**RE:** Petition No. 1768-second-revision  
Requested Encroachments At Various Location Surrounding 1400 Woodward  
(With Outdoor Seating, Planters, Exterior Lighting, Hotel entrance Awning And  
Other Awnings) Bound By Woodward, John R., Farmer, And Grand River Ave

### NOTICE OF PROPOSED CHANGE IN PROPERTY

**REQUEST ENCROACHMENT  
 VARIOUS LOCATIONS  
 AT 1400 WOODWARD**  
 (With Outdoor Seating, Planters, Exterior Lighting  
 Hotel Entrance Awnings and Other Awnings)

**RE: Request for 1400 Woodward Hotel Encroachment into the Woodward Avenue, John R Street, Farmer Avenue, and E. Grand River Avenue Public Right-of-Ways**

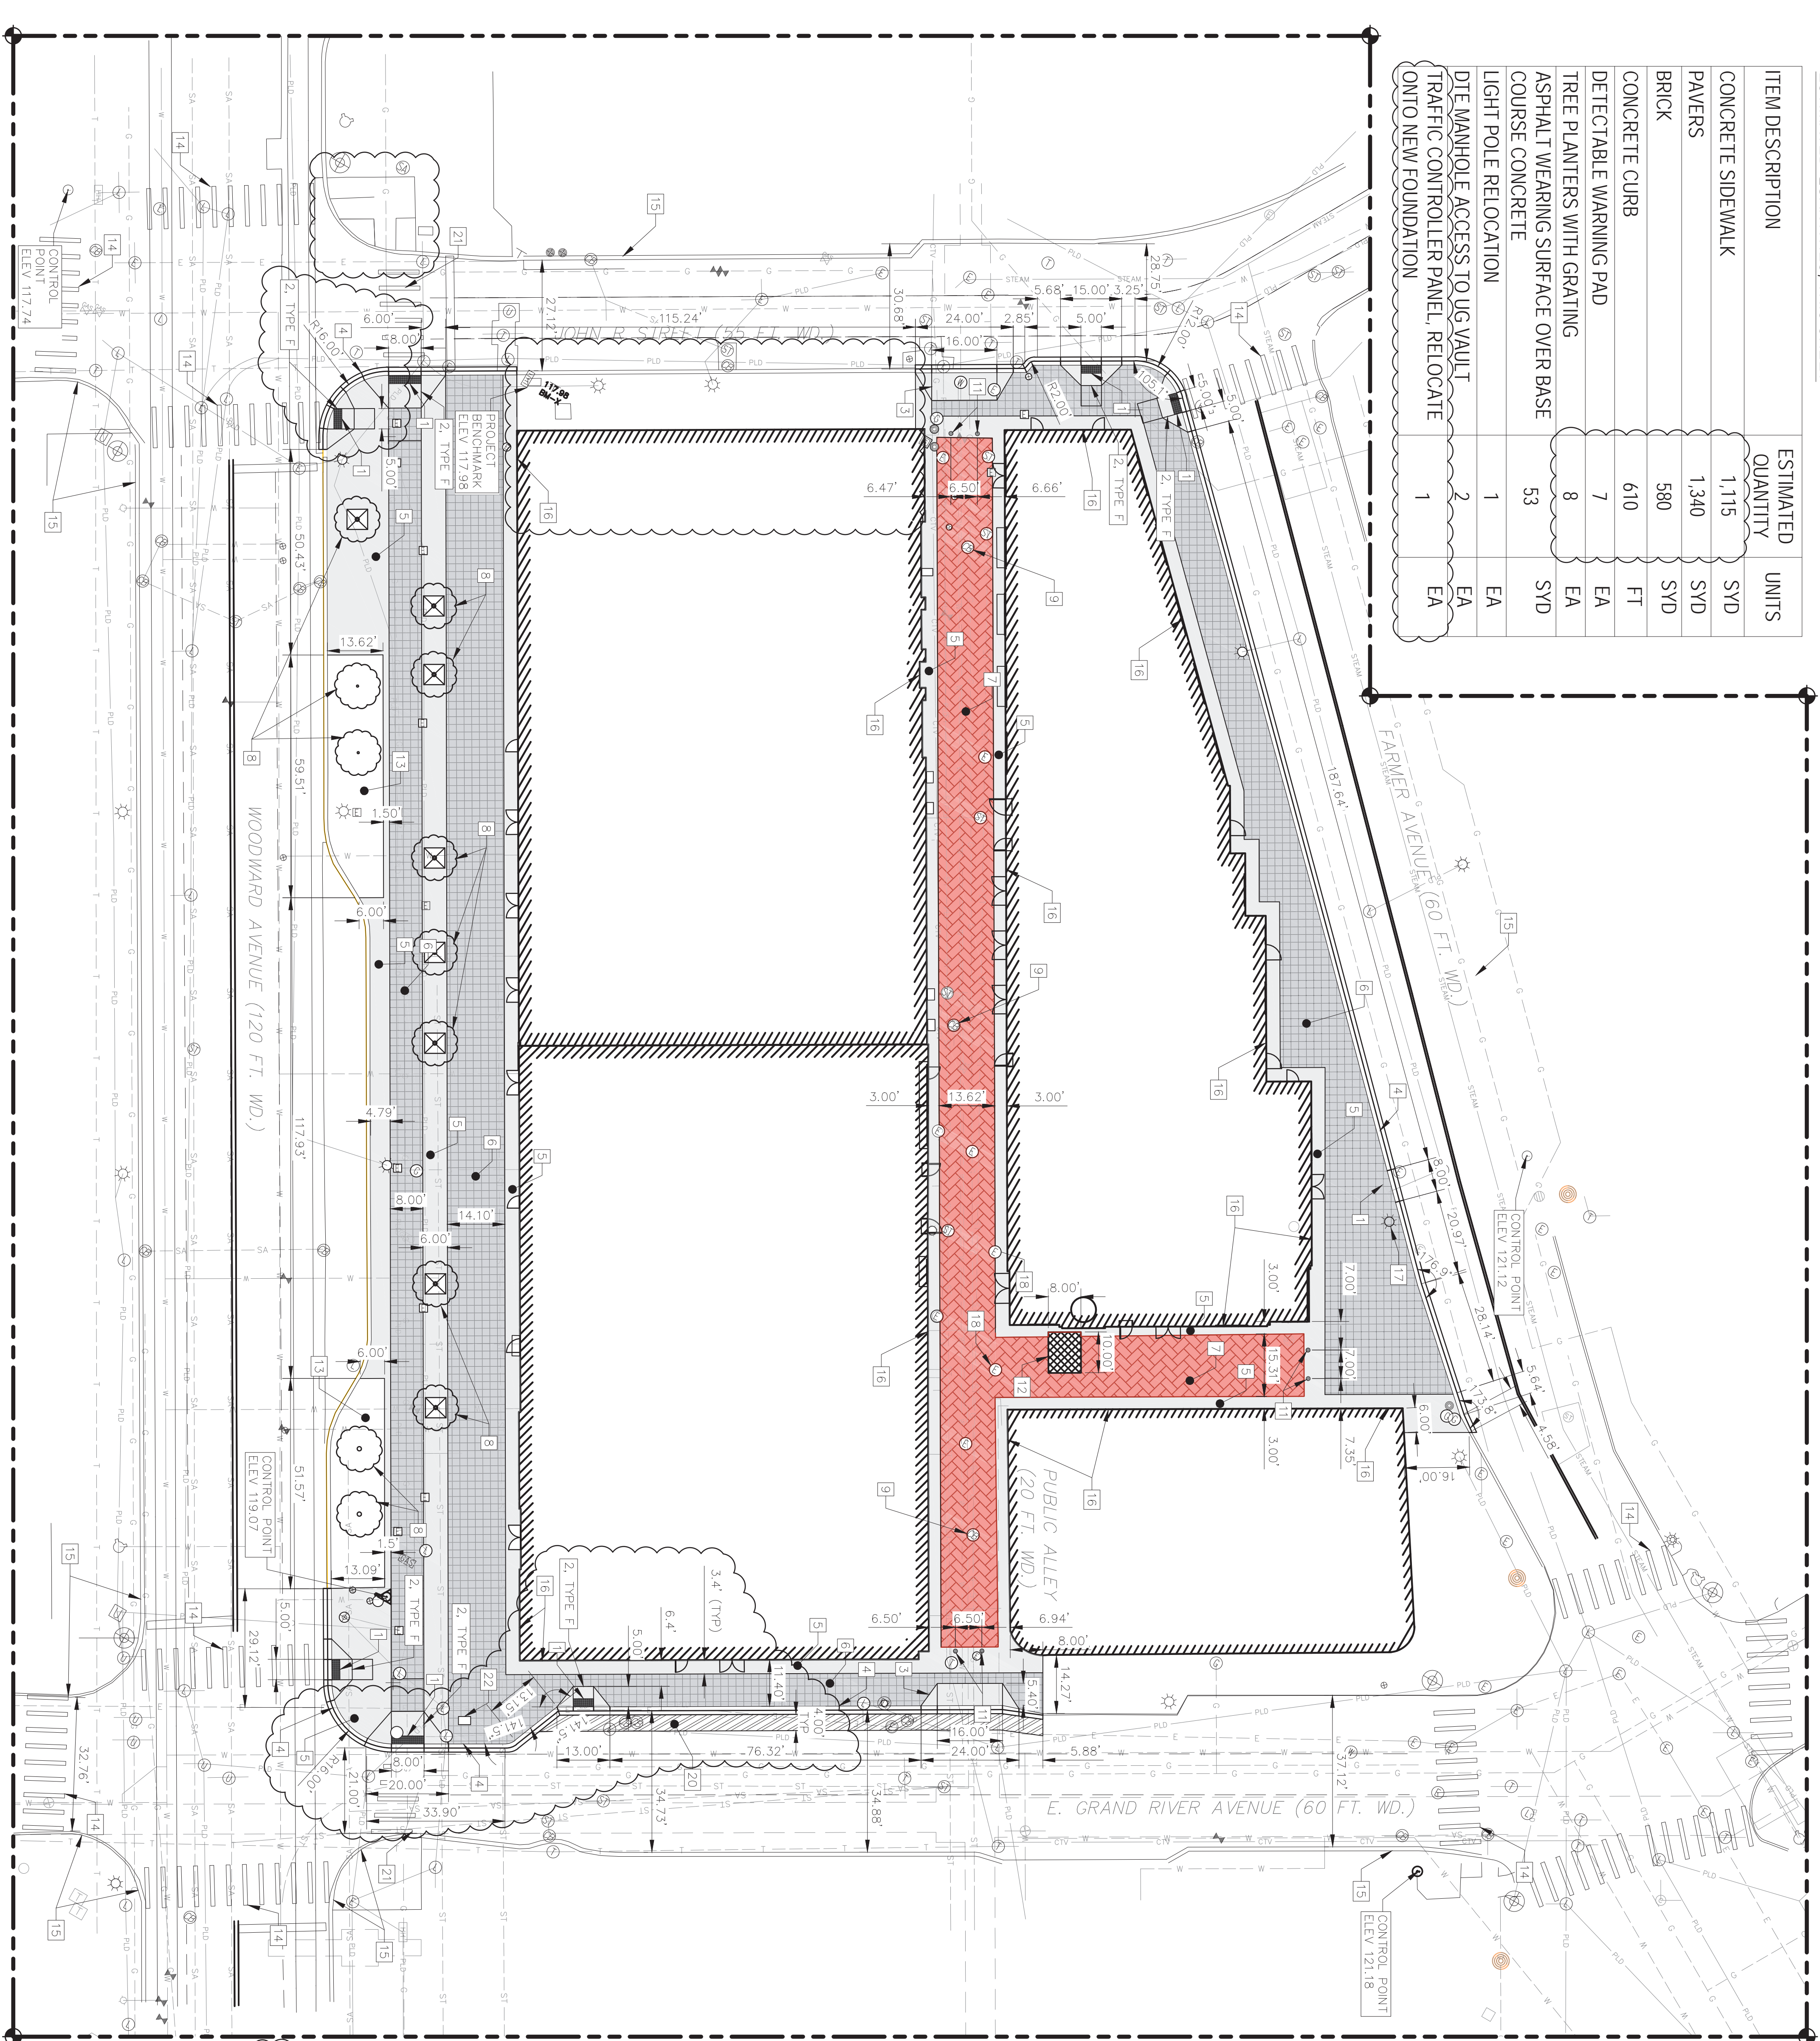
The second page for encroachments is primarily for all items at grade and below. This will include all the paving of the walks that are paver bricks, grates for the trees, the portion of landscaping below ground and irrigation for the landscaping.

Specifically pave bricks and their base material are located in all the shaded areas shown in the second page. Attached is the site plan showing the location of landscaping, there is no plan showing underground irrigation to the landscaping.

After reviewing the documents that you have provided, do you have any documentation on any encroachments that will be below ground?

MAINTENANCE ENCROACHMENT LIMITS INCLUDES THE AREA BETWEEN THE EXISTING RIGHT-OF-WAY AND THE EDGE OF ROADWAY PAVEMENT FROM THE SOUTH EDGE OF JOHN R. STREET TO THE INTERSECTION OF JOHN R. STREET AND FARMER STREET; THE AREA BETWEEN THE EXISTING RIGHT-OF-WAY AND THE ROADWAY EDGE OF PAVEMENT FROM THE INTERSECTION OF FARMER STREET AND JOHN R. STREET TO 7 FT EAST OF THE WESTERN EDGE OF THE PARCEL WITH ADDRESS 1401 FARMER STREET; THE AREA BETWEEN THE EXISTING RIGHT-OF-WAY AND THE EDGE OF ROADWAY PAVEMENT FROM THE INTERSECTION OF FARMER STREET AND GRAND RIVER AVENUE TO THE INTERSECTION OF GRAND RIVER AVENUE AND WOODWARD AVENUE; THE AREA BETWEEN THE EXISTING RIGHT-OF-WAY AND THE EDGE OF ROADWAY PAVEMENT FROM THE INTERSECTION OF WOODWARD AVENUE AND GRAND RIVER AVENUE TO THE INTERSECTION OF WOODWARD AVENUE AND JOHN R. STREET.

- THESE AREAS SHALL INCLUDE THE MAINTENANCE OF ALL MATERIALS (BEGINNING AT GRADE AND/OR BELOW GRADE) LISTED HERE:
- CONCRETE PAVERS, SAND BEDDING, AGGREGATE BASE
  - NON-STANDARD CONCRETE CURB AND/OR GUTTER
  - ADA-RAMPS AND DETECTABLE WARNING SURFACES
  - IRRIGATION LINES FOR LANDSCAPING
  - TREES AND TREE GRATES
  - LANDSCAPING BEDS AND PLANTS

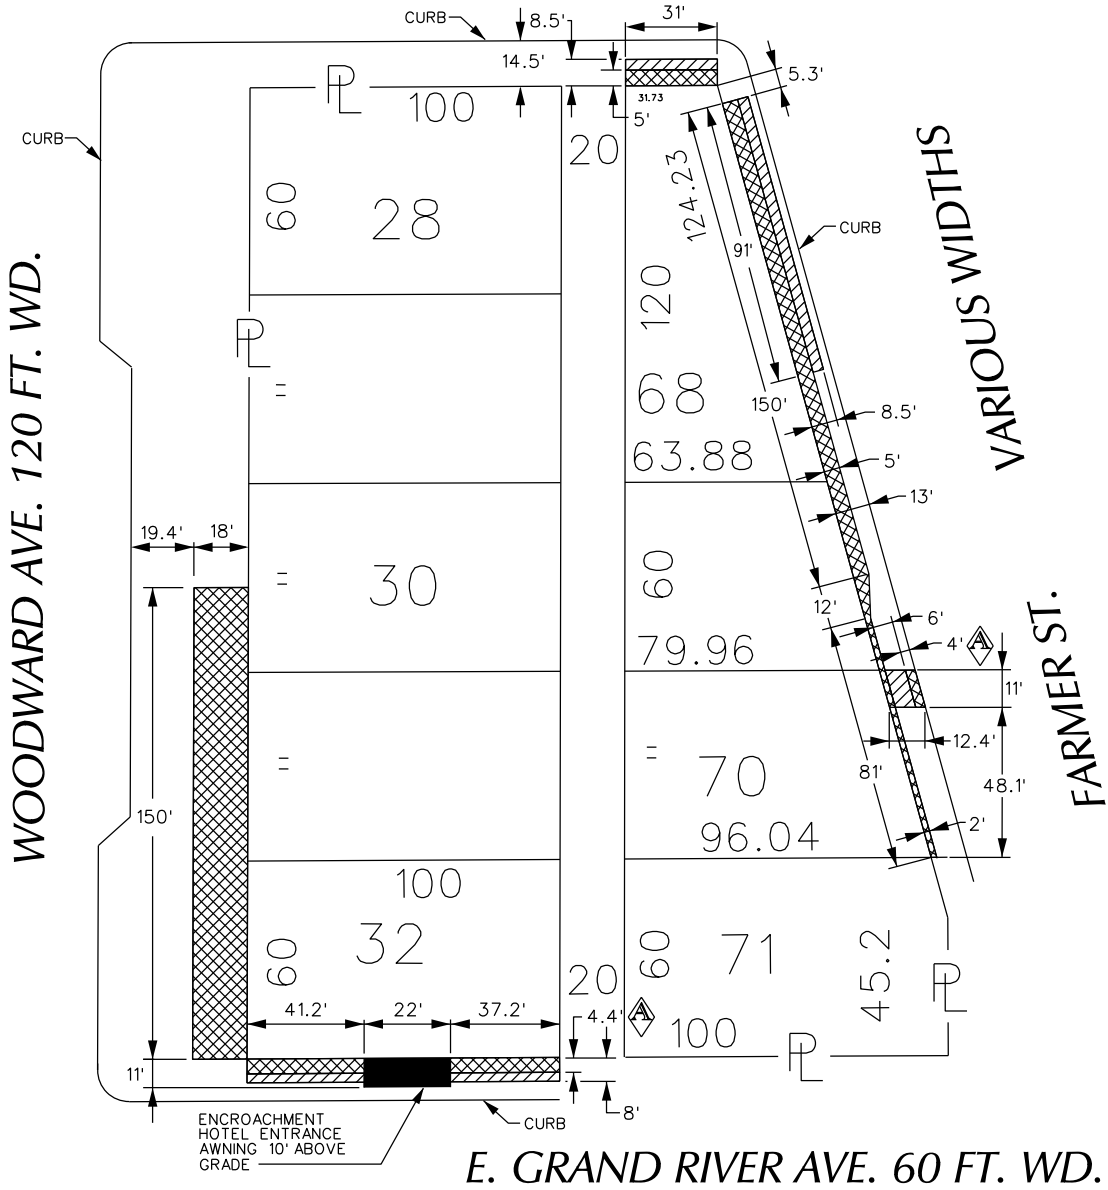
I met with Dave earlier and he mentioned that you have revised the awning along Farmer. I was talking to Walter Williams at Survey Bureau and he mentioned that he has not received any revised plan showing the revised encroachment with awning along Farmer. Please send it over to him asap so that he can revise the drawing for petition # 1768.

<b>B</b>					
<b>A</b>	MAINTAINING A 6' WALKWAY ALL AROUND	WLW	KSM	KSM	5/9/18
<b>DESCRIPTION</b>		<b>DRWN</b>	<b>CHKD</b>	<b>APPD</b>	<b>DATE</b>
<b>REVISIONS</b>					
<b>DRAWN BY</b>	WLW	<b>CHECKED</b>			
<b>DATE</b>	04-05-18	<b>APPROVED</b>

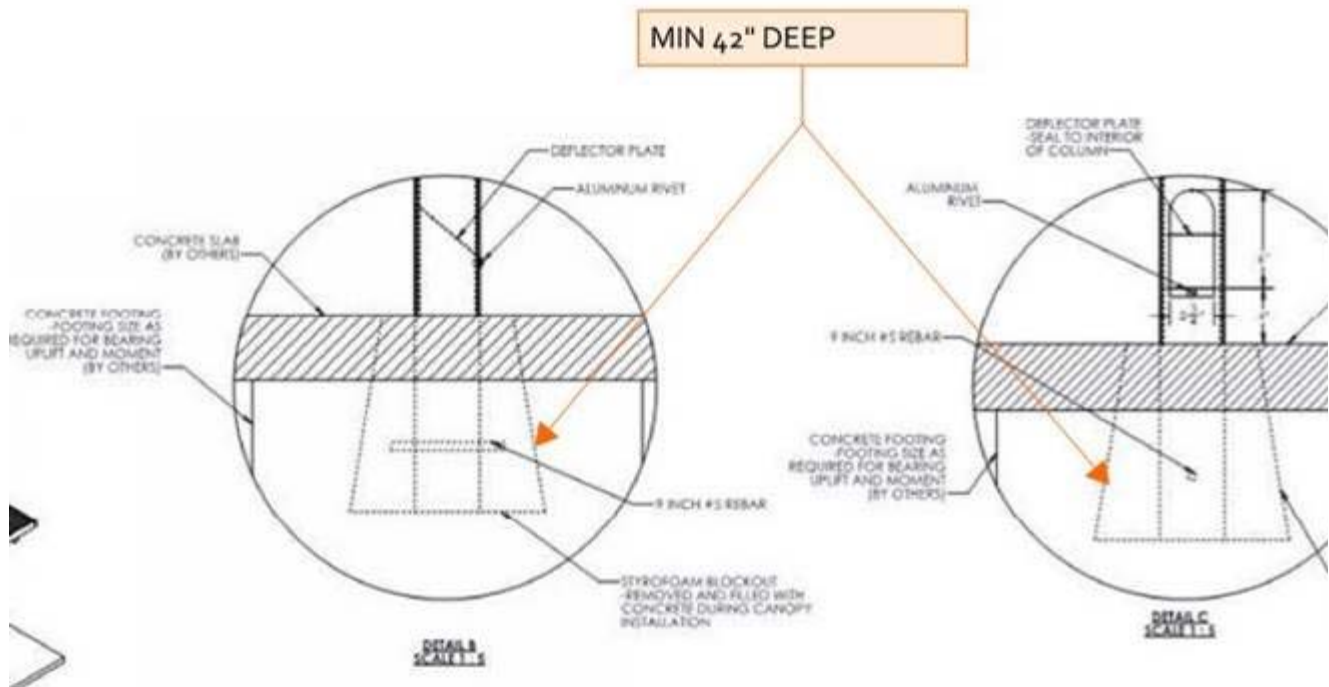
Per request from DWSD we need the mounting depth.

For encroachments such as the Petition 1819 where items are mounted into the ground, can the petitioners please be asked to provide the depth below ground of the mounted items not just the width/length/height?  
Thanks
